From: Dannielle Teran
Sent: 10 May 2019 11:56
To: Adam Watts
Subject: FW: RIVERSIDE OPEN SPACE & HCRC Objection to 2018/3803
Attachments: Screen shot 2019-05-08 PP for opening to rear boundary wall to JB site.png; 46e63317-5068-4576-8d1c-7018eac6654a.png; Landing Stage & embankment walls.JPG; 1995 JB site plan from 1996 0119.pdf

From: Karen Liddell [REDACTED]
Sent: 08 May 2019 [REDACTED]
To: Jennifer Margetts <JMargetts@elmbridge.gov.uk>
Cc: Andrew Roberts [REDACTED]; 'Ray Townsend' [REDACTED]; Deborah Bird [REDACTED]; [REDACTED]; 'Nicola Andrews' <Nicola.Andrews@elmbridge.gov.uk>; [REDACTED]
Subject: RIVERSIDE OPEN SPACE & HCRC Objection to 2018/3803

FURTHER OBJECTION FROM HCRC RE RIVERSIDE OPEN SPACE ISSUES

CONTRACT
CHILTERN INNS
THE JOLLY BOATMAN
HAMPTON COURT
DRAWING
SITE PLAN

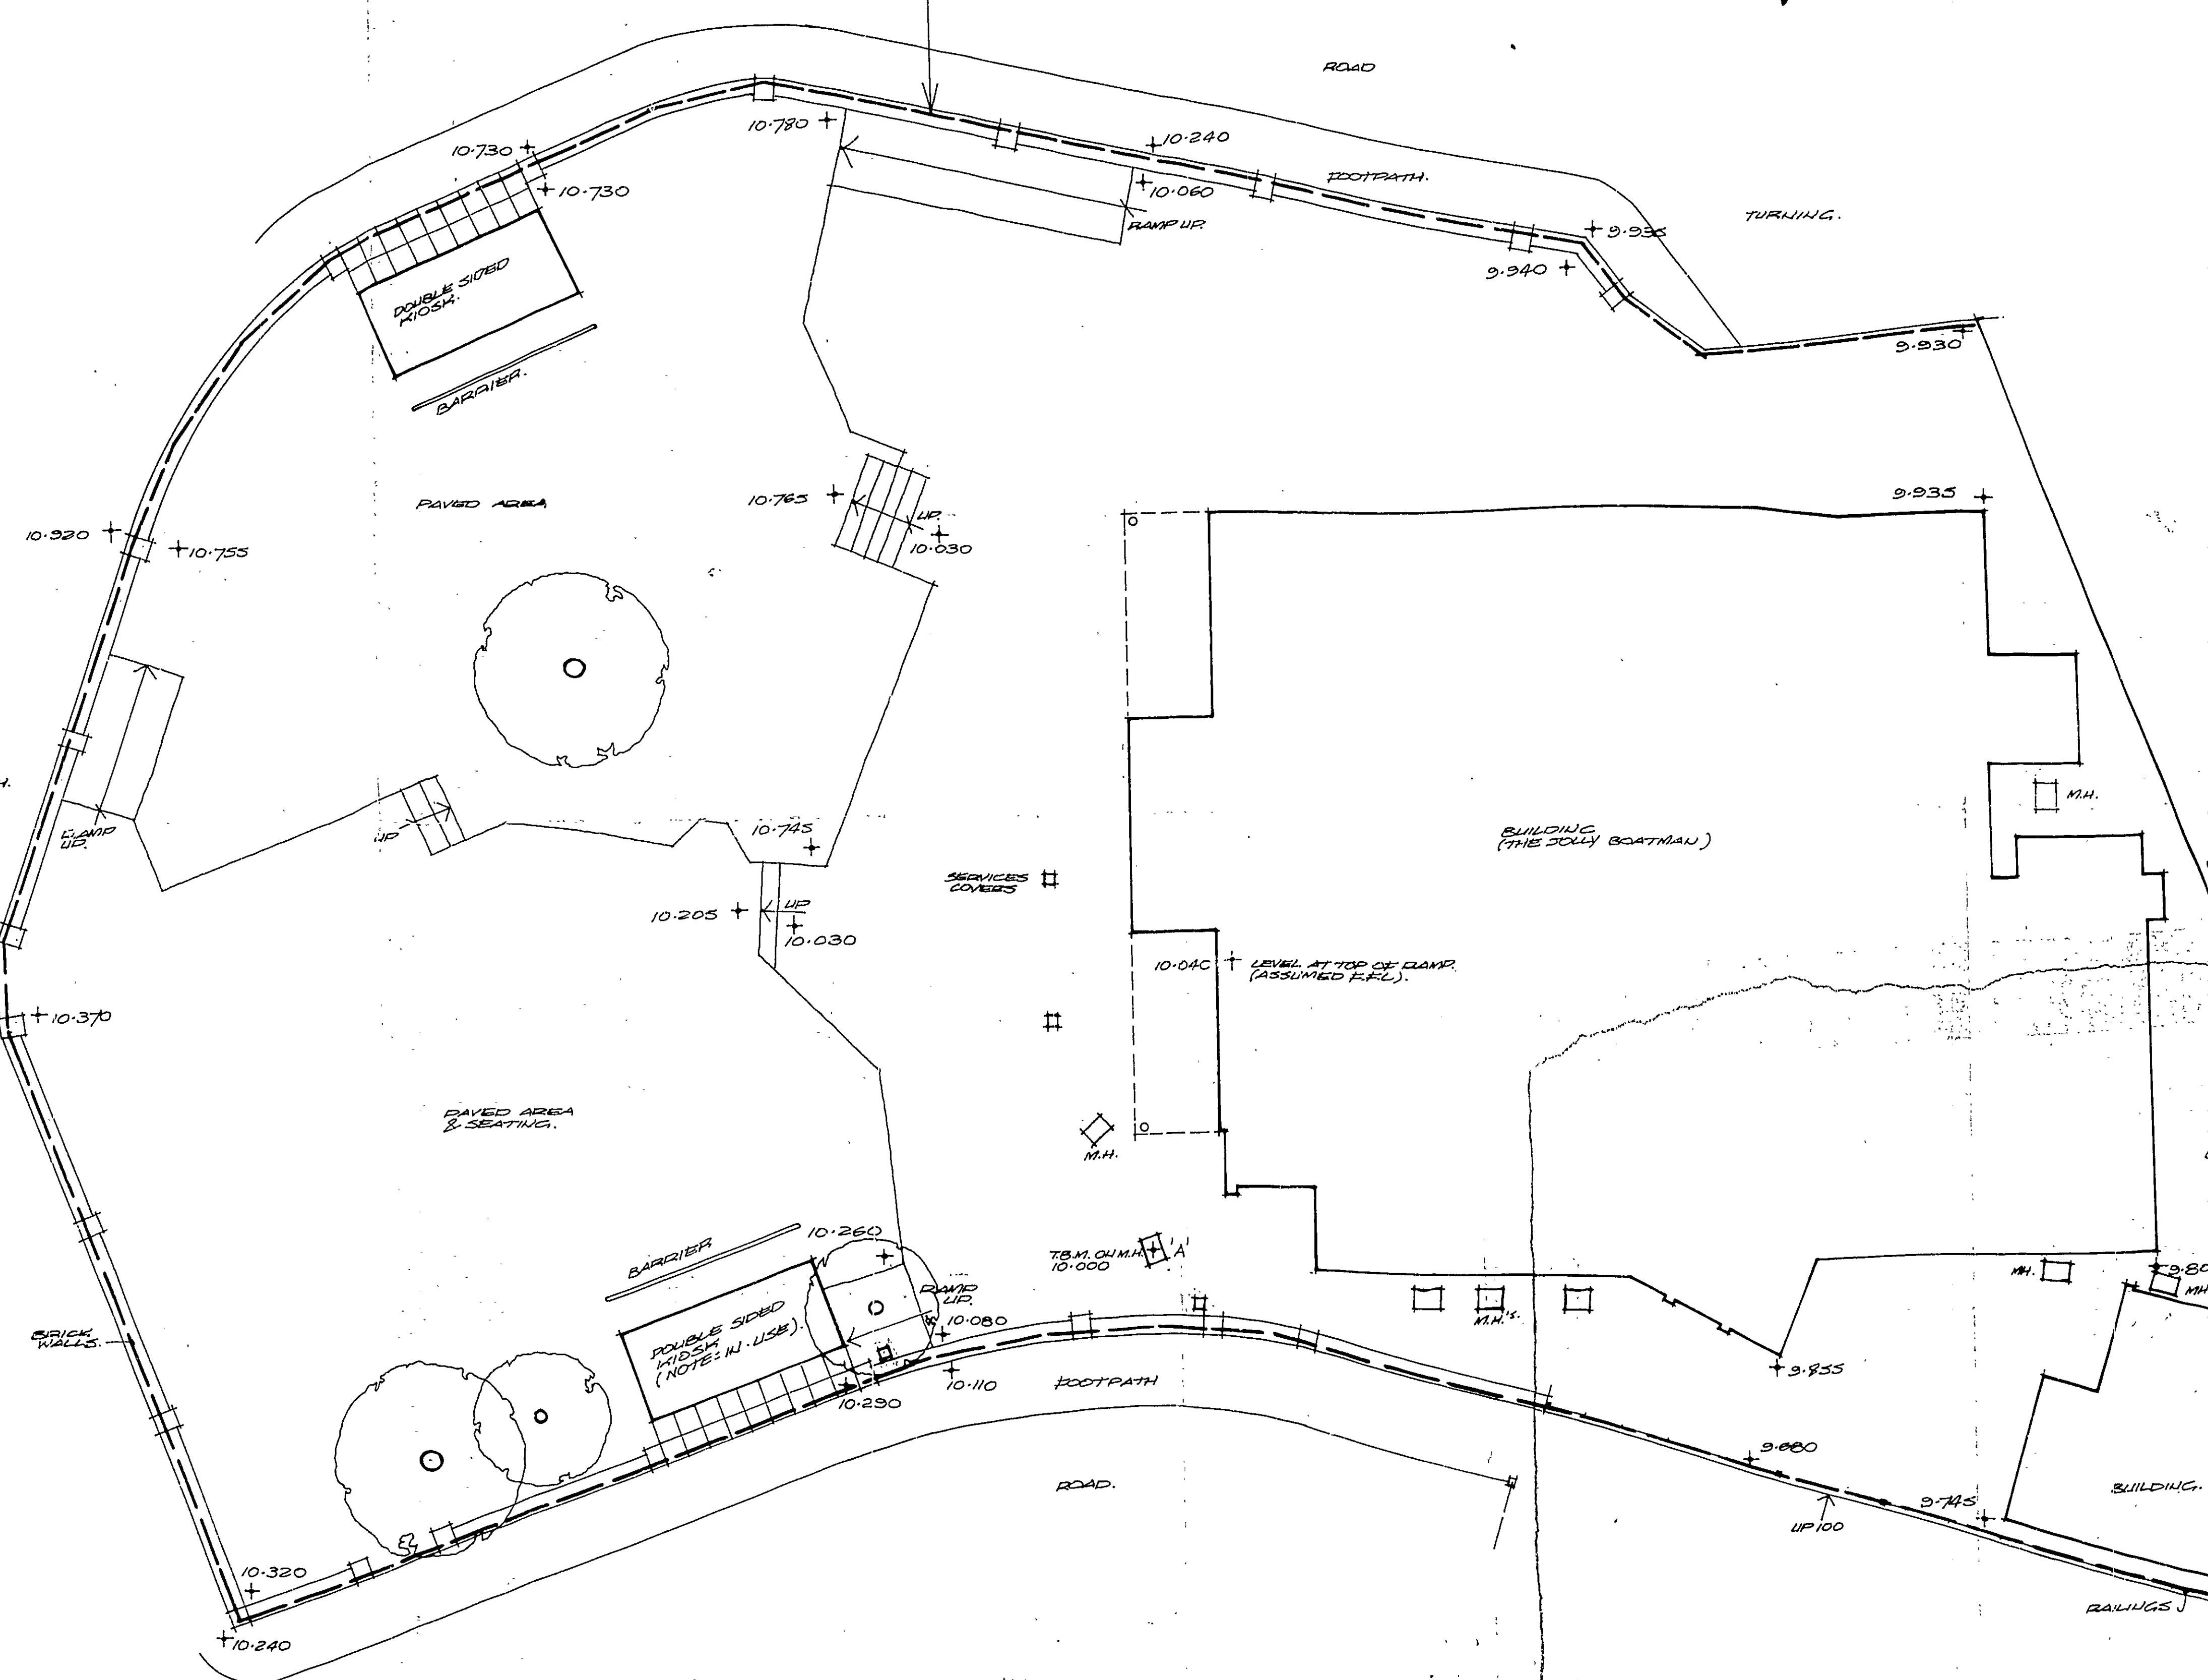
1. The wall to Cigarette Island Park - I note that James Owen in his email of 9/4/19 is of the view that the wall is not owned by Alexpo. I agree with AR that looking at its quality, alignment and age it is most likely to be part of the historical JB site. Looking at the Land Registry plan I cannot see why the owner would refute ownership. I attach a screen shot of a planning approval in 1968 for a sales opening in the rear boundary wall facing CI which was made by the then owners Mecca. I also attach a site plan from 1995 (from 1996/0119) clearly marking the boundary wall with a building attached to it. There are other applications for earlier hoardings that are on the alignment of the wall and indeed I believe the current hoarding is attached to the wall. It is unfortunate that documents are not available for earlier applications on the JB site but maybe you have access to them or to the Building Control Records. I am of the opinion that the 1968 planning permission description is referring to the wall we are concerned with and that the opening is still visible and thus the wall must be in the ownership of Alexpo. As explained in my previous email HCRC has been campaigning with HRP for many years to connect an open space at the landing stage to CI park. Setting aside our concerns about the totality of the scheme, we are concerned that the desire and opportunity to open up the space is being ignored and missed. JO's email of 9/4 demonstrates a misunderstanding of our objectives in that he states "the wall helps to provide enclosure to the park and appropriately define the edge of the urban/built up area". Please see the historic photos of the park from the mid and late 1950's when the riverside banks were kept clear of planting and accessible for public use. The planting of the Holm Oaks along the banks and leaving nature to take over was in our opinion a poor decision and has reduced the public's enjoyment of the banks. We consider that the Design Team are not listening to the communities objectives in stating that "there is some merit in keeping the it (the wall), together with the low levels wall and obelisks that flank the park entrance". The low wall and obelisks are not connected to the older wall, and the wall does not form part of the listed building structure of the Lutyens bridge and landing stage. He is correct there is no need to touch the obelisks that do not belong to Alexpo, but there could be a creative scheme by specialist landscape architects to redesign and relocate the focal entrance to the park. The 1950's photos show that the original intentions of the park opened in 1935 was to create an open space for the community to enjoy views of the river and Palace, and indeed it was used for the local carnival before the riverbank was left to naturalise. Whilst the positioning of the projecting wing to the

riverside block undermines our desire to fully open up the riverside from the bridge through to the park, removing the wall would at least give greater opportunity for more creative landscaping. The retention of the wall will simply reinforce the private nature of the new open space. We should not be misled into believing this proposal includes a public space if the intention is to create a private open space.
